H12444

DESCRIPTIVE REPORT

Sublocality Southwest of Avatanak Island

The purpose of this survey is to provide contemporary surveys to update National Ocean Service (NOS) nautical charts. All separates are filed with the hydrographic data. Notes in red were generated during office processing. The processing branch concurs with all information and recommendations in the DR unless otherwise noted. Page numbering may be interrupted or non-sequential. All pertinent records for this survey, including the Descriptive Report, are archived at the National Geophysical Data Center (NGDC) and can be retrieved via <http://www.ngdc.noaa.gov/>.

Figure 2 Profile of 1P601-TIE07

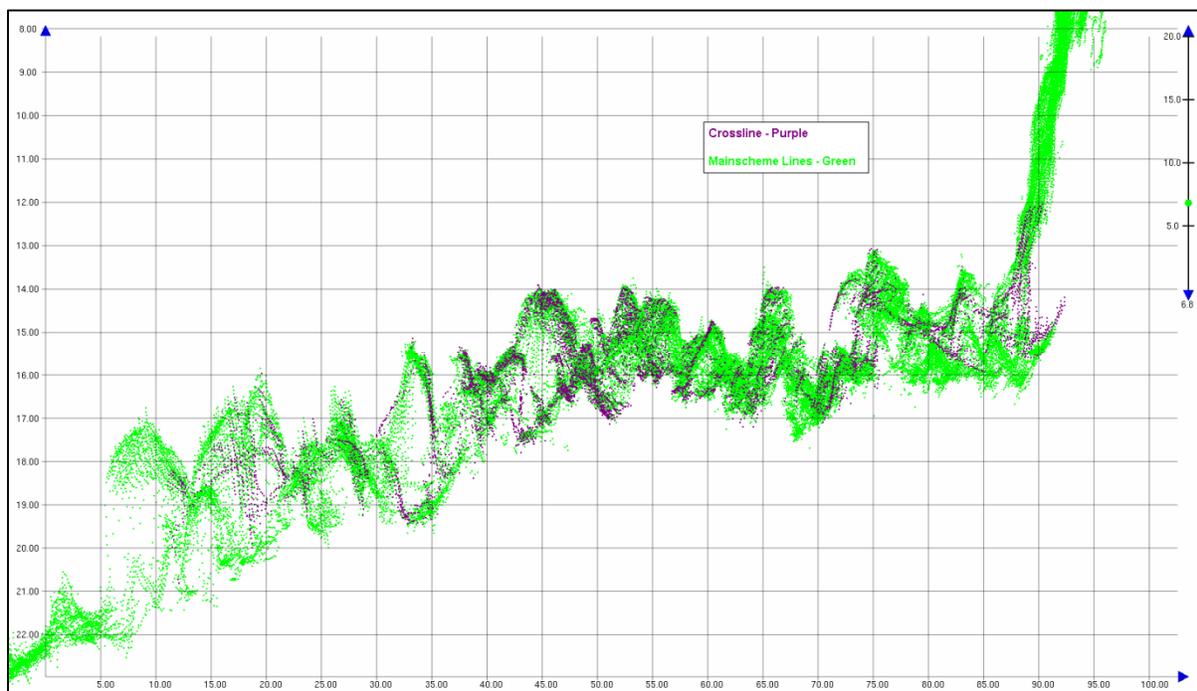
The majority of QC Reports fall well within the required accuracy specifications. However, crosslines run by R/V R2 nearshore to Avatanak Island contain beams in the QC report that fall below the 95% confidence level due to significantly rocky topography as illustrated in **Figure 2**. Good conformity was still seen between mainscheme lines and crosslines. Mainscheme lines are shown in green and the crossline in purple. Quality Control Results are located in Separate II. ²

² The effect of slope and rocky seafloor on confidence level are as expected. Resulting depths were used for updating the chart, but enclosed inside rocky area features as an added precaution.

Figure 8 Vertical Bust in Chimney Cove on the Southern Shore of Avatanak Island

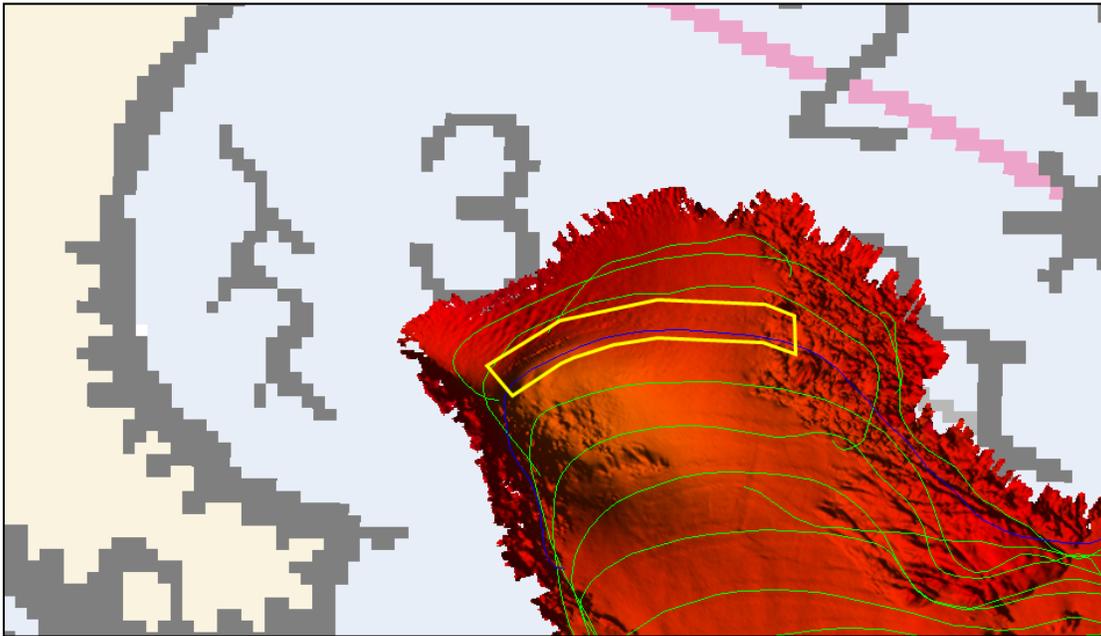
4. A vertical bust up to 0.60 m was found at approximately 54° 04' 15" N, 165° 38' 53" W,⁴ located in Chimney Cove. It measures 200 m in length, running east to west. The vertical misalignment may be due to local effects and could not be adequately modeled with discrete tidal zoning (**Figure 8**).⁵

⁴ Longitude given for Chimney Cove is incorrect. Correct longitude is 165°22'00"W.

⁵ During office review the vertical bust in Chimney Cove was found to be up to 0.8m. This data was rejected, but did not result in loss of coverage since there was sufficient overlap with adjacent line data.

Figure 9 Contours and Charted Soundings to be Modified in the ENC and RNC

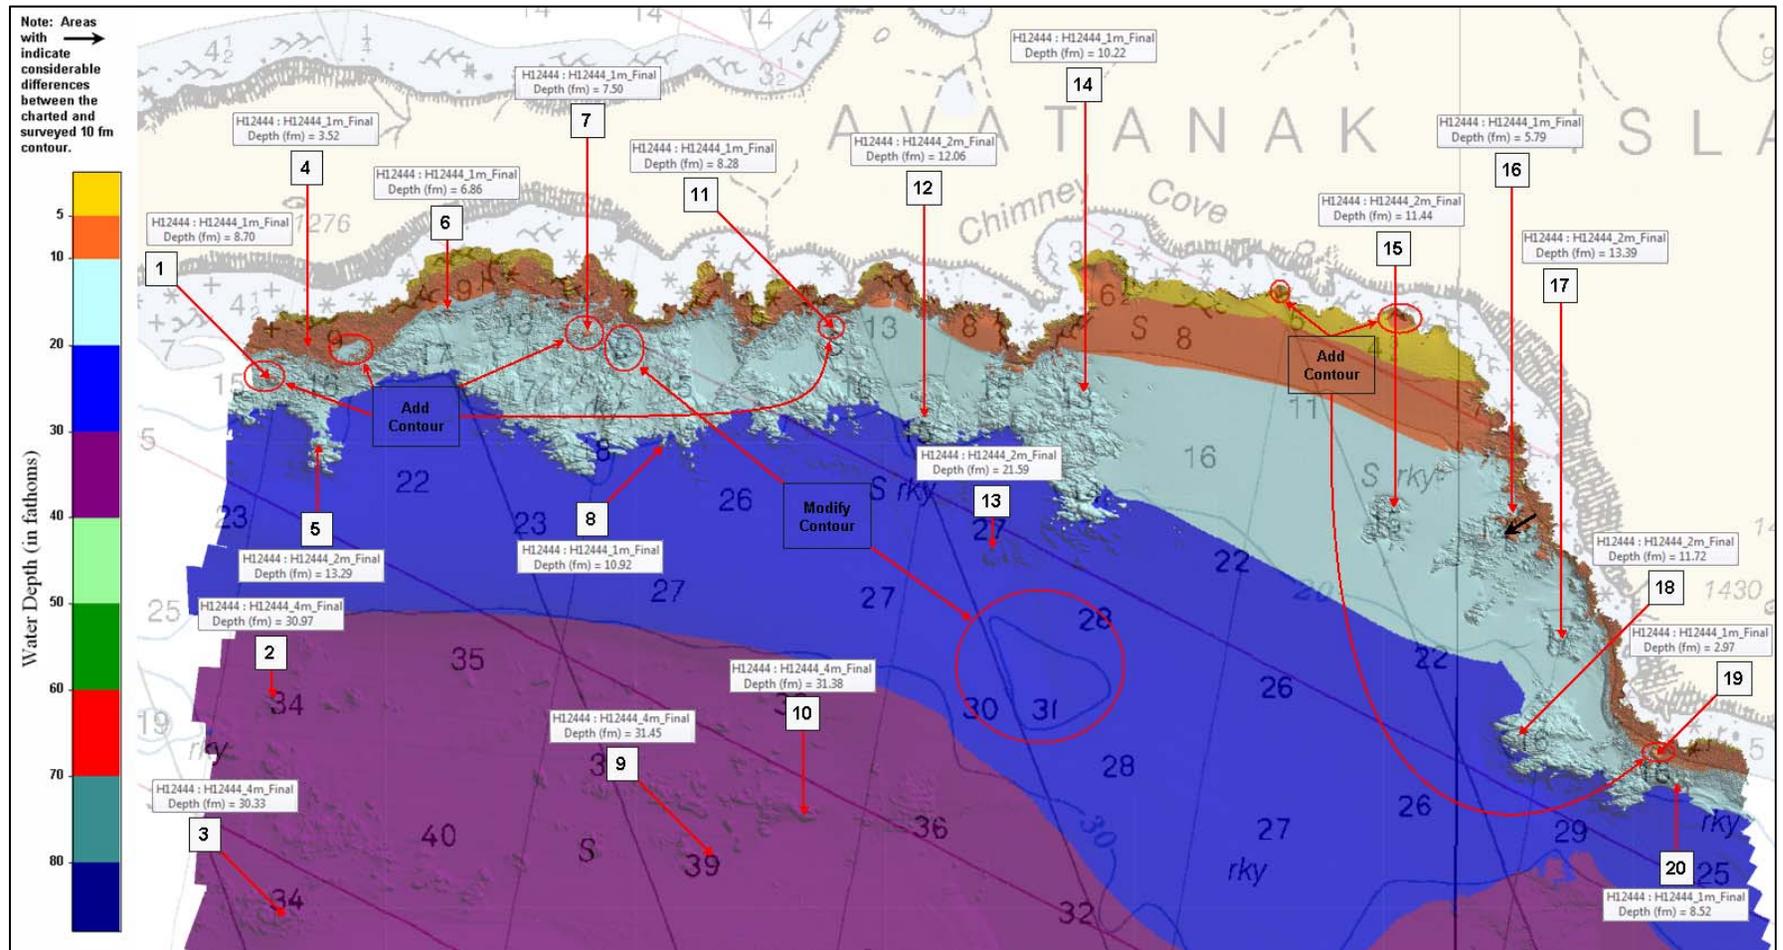
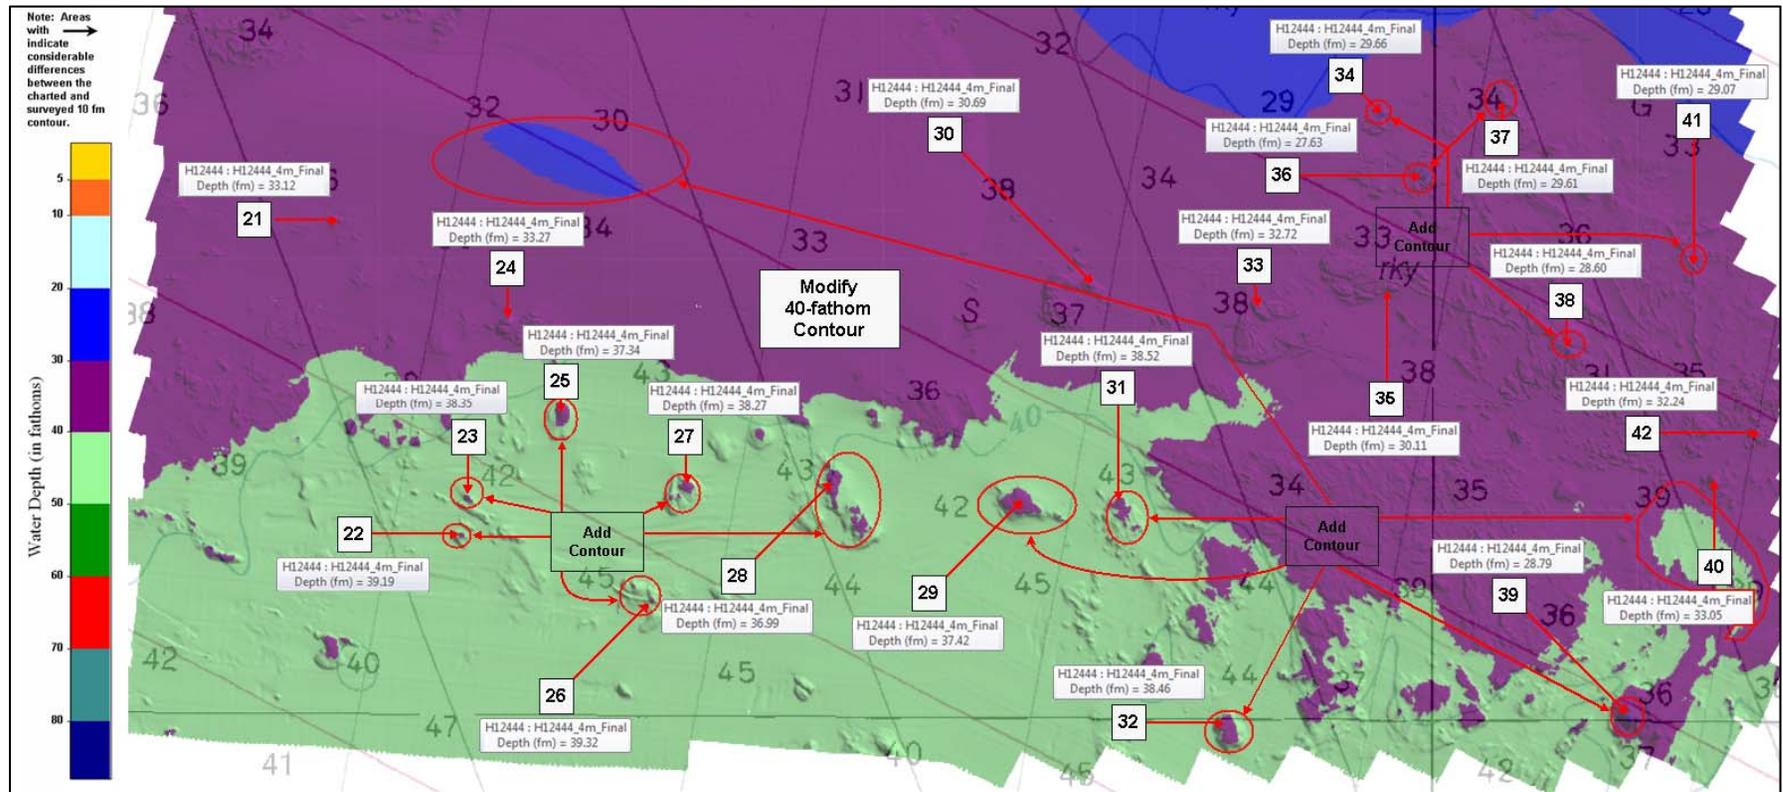
Agreement between the H12444 BASE surface depths and the charted soundings for all applicable ENC and Raster charts was within +/- 3 fathoms. Since the survey area was ensonified with 100% multibeam coverage, discrepancies were discovered between the charted soundings and the surveyed depths. Results are listed in **Table 4** below, and are also presented in **Figure 9** and **Figure 10**. Special attention was given to soundings with greater than 2 fathoms difference.⁸

⁸ Some, but not all, soundings listed in Table 4 have been compiled to the chart update product.

Figure 11 Northern Area of H12444 - Proposed Modifications to Contours

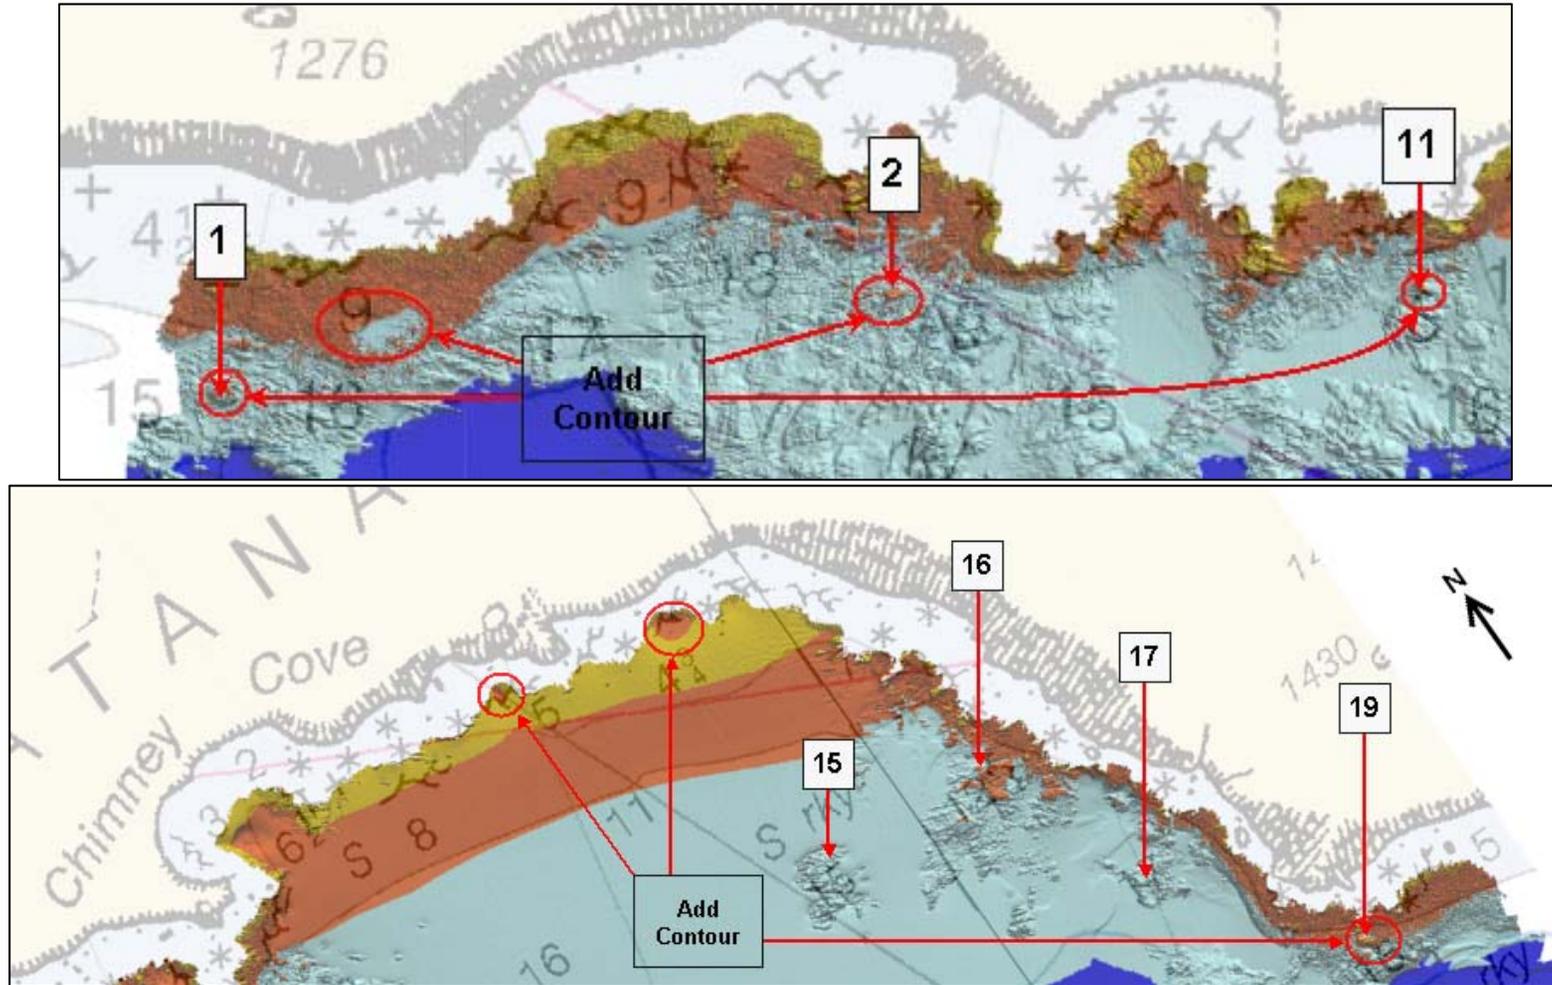
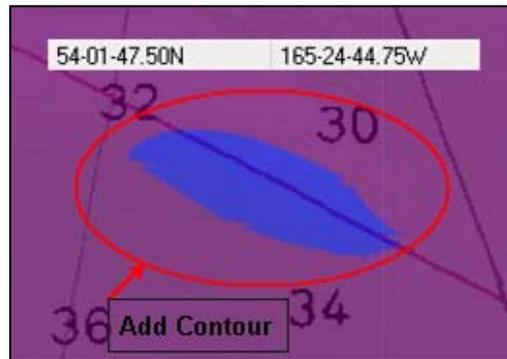
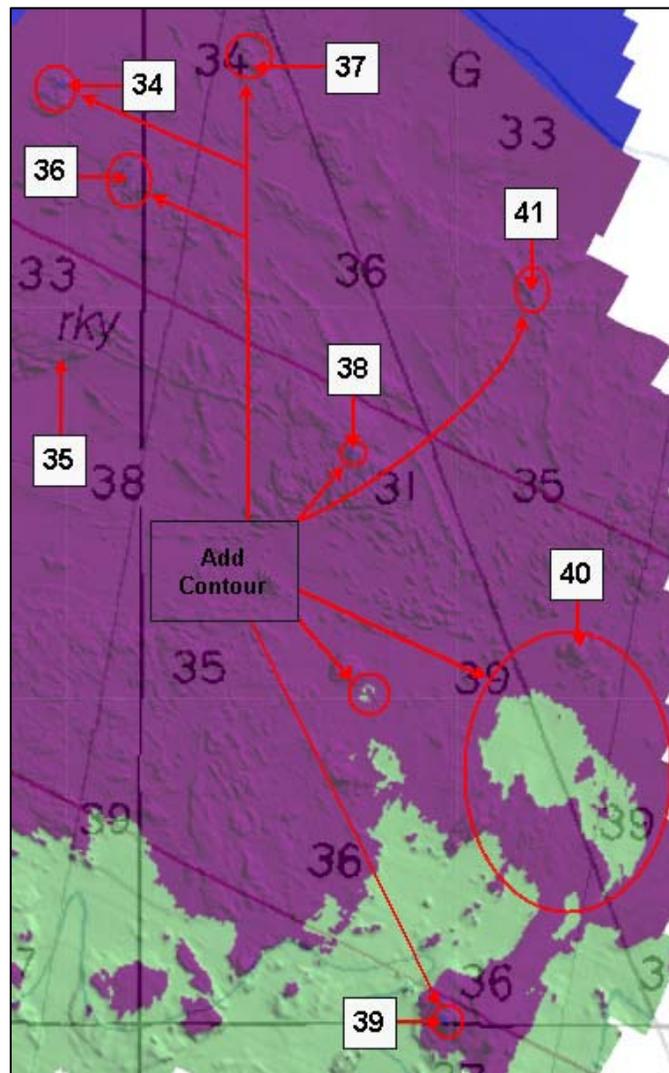
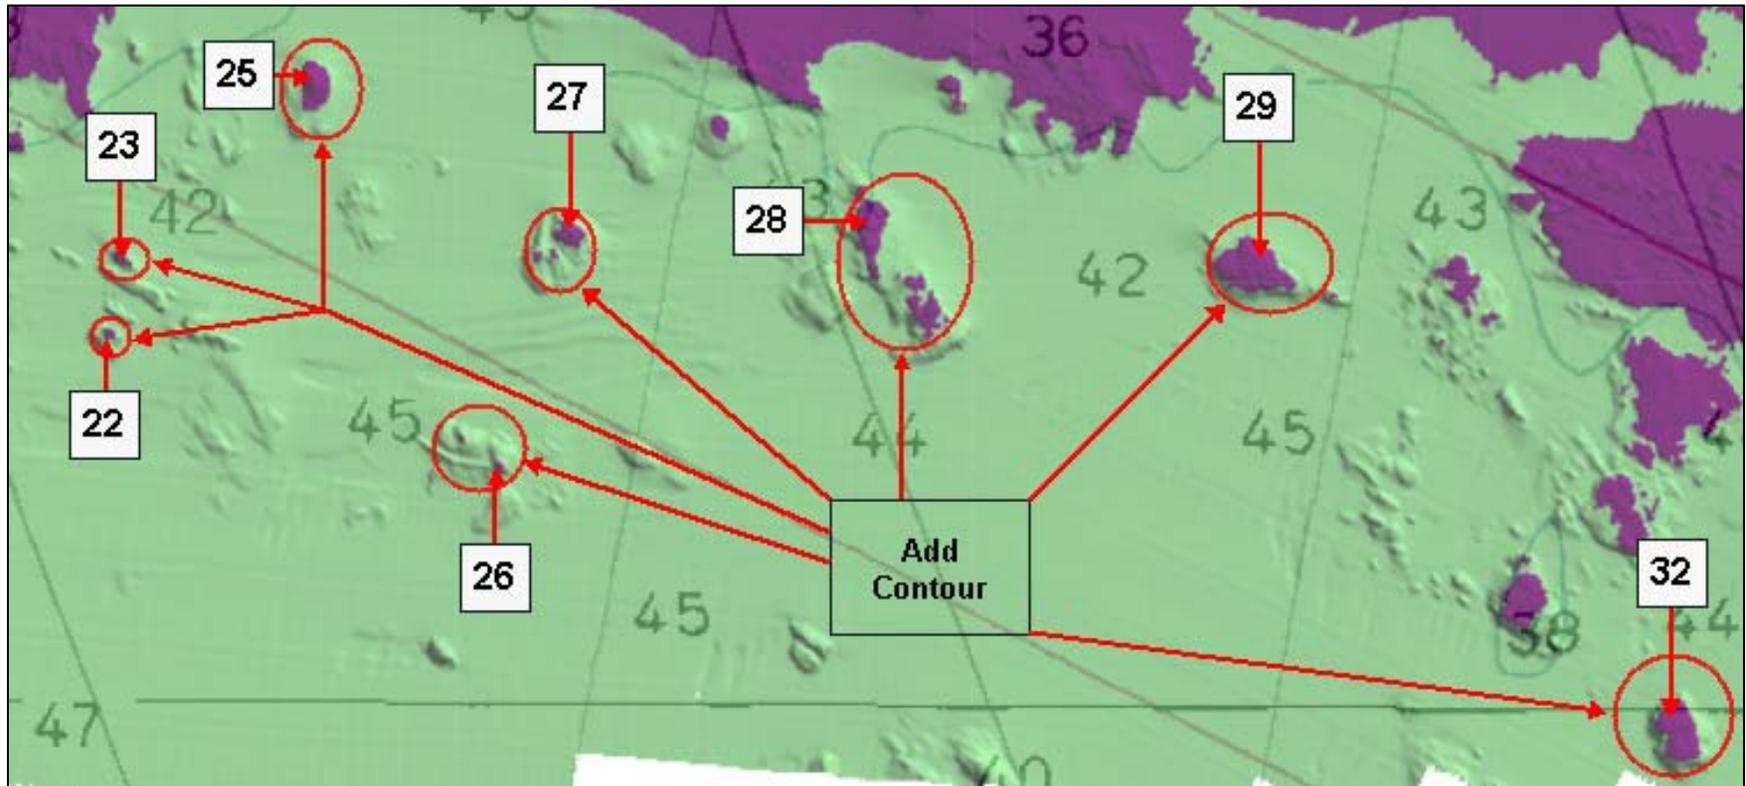
1. Overall, the 100% multibeam coverage established discrepancies between charted and observed contours. Several new contours were discovered throughout the survey area; specifically around items 1, 2, 11, 19, 22-23, 25-29, 32, and 34-41. These new contours and their locations are identified with arrows stating “Add Contour,” as shown below in **Figure 11**, **Figure 12**, **Figure 13**, and **Figure 14**.¹⁰

¹⁰ Contours for the chart update product are derived from the Combined BASE Surface. Final placement of depth curves for the chart are determined based on a number of factors, including soundings selected for compilation and the scale of the chart.
